MCPB
Item No.: 3
Hearing Date: 1/8/15

7206 Meadow Lane, Limited Amendment 12010027A (in response to a violation)

Amendment application to retain an existing paved pathway that otherwise is to be demolished under the existing approved plans and associated terms of the Modified Category I Easement.

Aerial site photo (prior to construction)

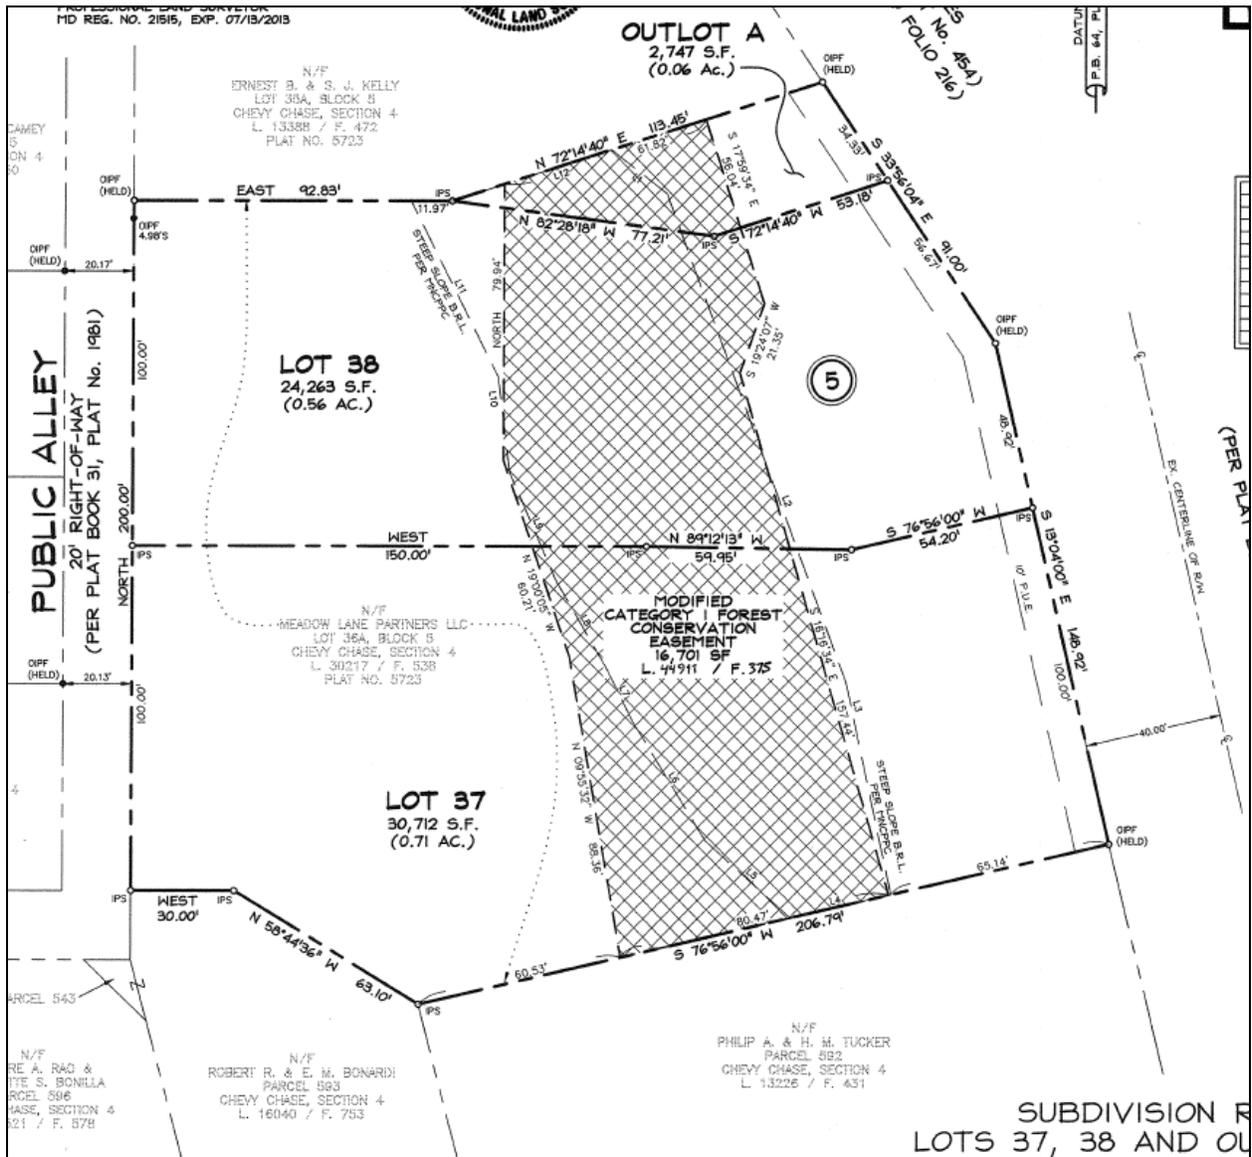
The former residence that had occupied the property was demolished before the original subject application was submitted. An associated walkway with steps made of concrete and a partial stone veneer remained. The pathway runs perpendicular to the slope and the location had been known for some time and was labeled as existing concrete steps on the NRI/FSD approved on February 23, 2010. The pathway was partially covered in years of leaf deposits and was not fully mapped out on the plans. The Final Forest Conservation Plan has a note pointing to the area of the walkway (and the associated retaining walls) which clearly states “Ex walls, walks etc. to be removed by hand as directed by arborist”. The approved Preliminary Plans also contain a similar note.

Location of existing concrete path and two approved, but unbuilt pathways North ↑

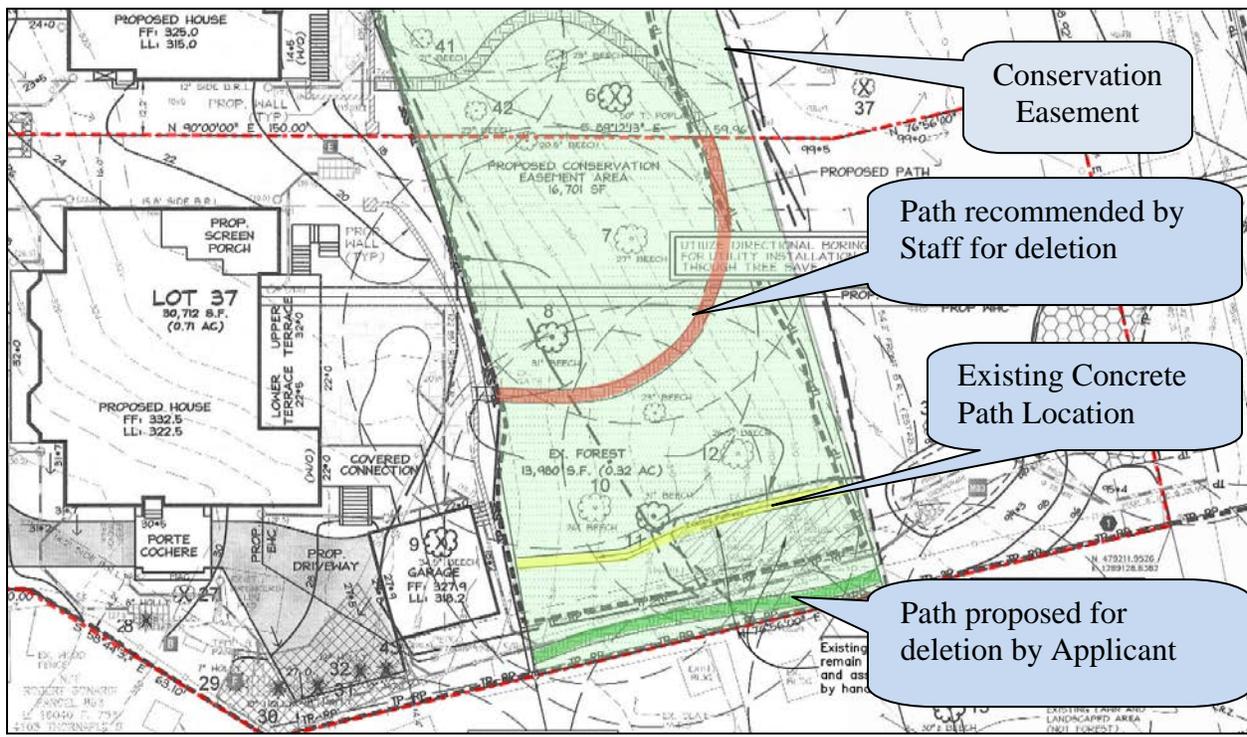
In exchange for keeping the existing path, one of the approved but unbuilt pathways on the subject lot will be deleted from the plans (refer to exhibit below). The path proposed by Staff to be to be deleted is a longer and windier path (in the north center of the subject lot) which potentially affects a greater number of trees and shrubs. Its removal from plans compensates for the existing concrete path to be retained.

On December 17, 2014, Staff received correspondence from the Applicant in which he proposes to keep the northern pathway on the plans (in addition to the concrete path) and instead delete the southern pathway. He would agree to delete both unbuilt paths from the plans if Staff withdraws the recommended conditions regarding revision and re-recording of the easement agreement and plat. Additionally, the Applicant requested that a plan note appearing on the submitted plan addressing the vertical fill (shown in photo above) be removed from the plans. The request also asks that certain notes regarding previous inspections be added to the plans.

- 1) The Applicant must revise and submit the Preliminary Plan and Final Forest Conservation Plan (FFCP) to formally delete the proposed, but unbuilt, northern pathway connection within existing Lot 37 and revise associated notes accordingly.

Staff does not support the Applicants' December 17, 2014, requests. The southern pathway proposed for deletion is associated with a utility corridor area that was recently disturbed by heavy equipment for the installation of the new utilities serving the development. The pathway was designed to coincide with area of disturbance thereby minimizing further environmental impacts potentially associated with path construction. By contrast the northern path is longer and winds through areas that were generally undisturbed by the development. Furthermore, Staff notes that the revision to the easement language and plat are needed simply because the paved path is expressly precluded by the existing Modified Category I Easement language. The existing fill/rubble (although not specifically addressed by the NOV) should have been previously removed by the applicant; the proposed plan notes will clarify the need to address the unstable fill and rubble. Finally, the additional notes regarding inspections that have occurred on the site have already been independently issued in writing by the M-NCPPC inspector. Therefore the notes would unnecessarily complicate the plans.
